Addendum No. 1

Contract No.: DA00518

Replacement of Bridge #25 on SR 1144 (Foreman Bundy Rd) over Canal in Pasquotank County

STANDARD GUARDRAIL ANCHORAGE DETAILS FOR VERTICAL CONCRETE BARRIER RAIL

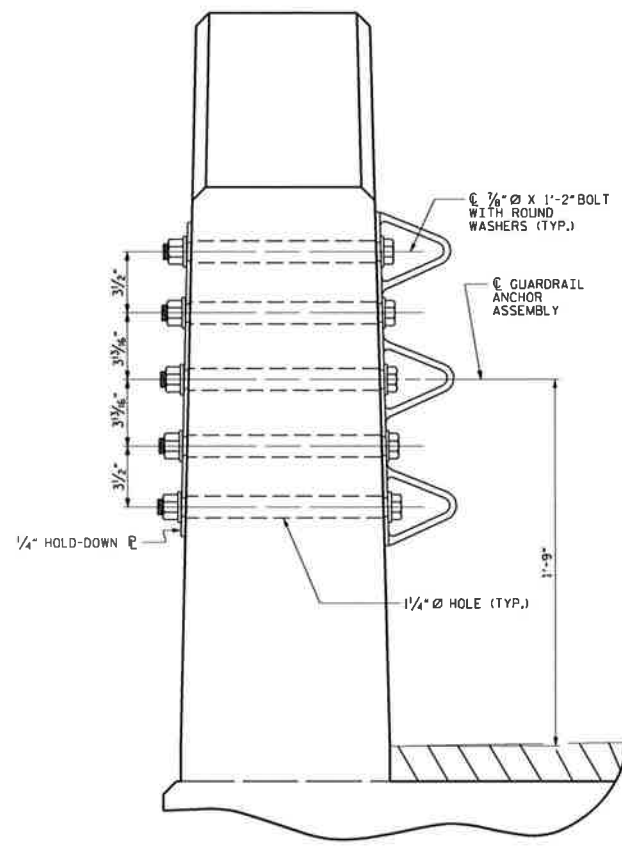
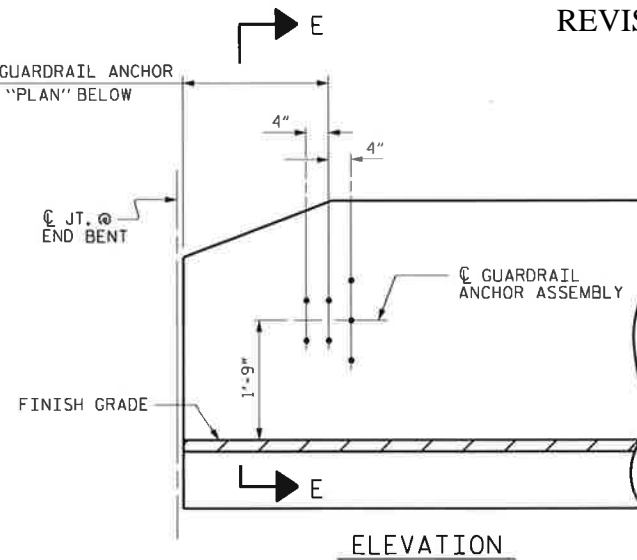
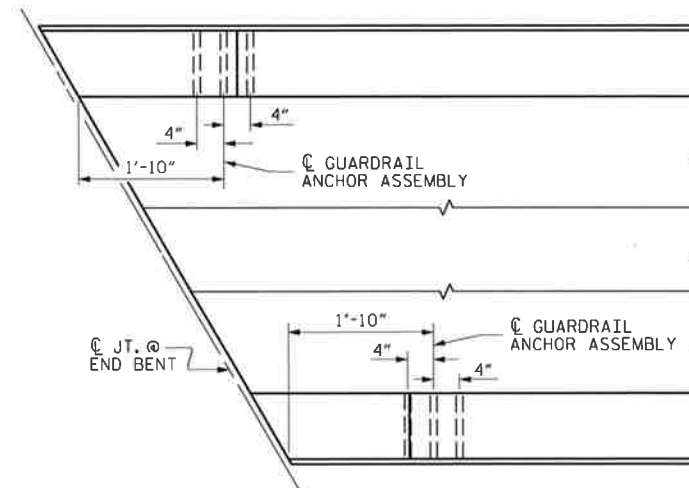
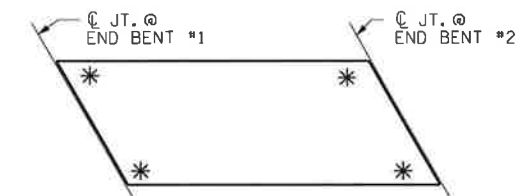
Plan Sheet No.6A has been included to clarify the requirements of attaching the guardrail anchor units to the structure. Please insert Plan Sheet No.6A in the plan sheets previously provided.
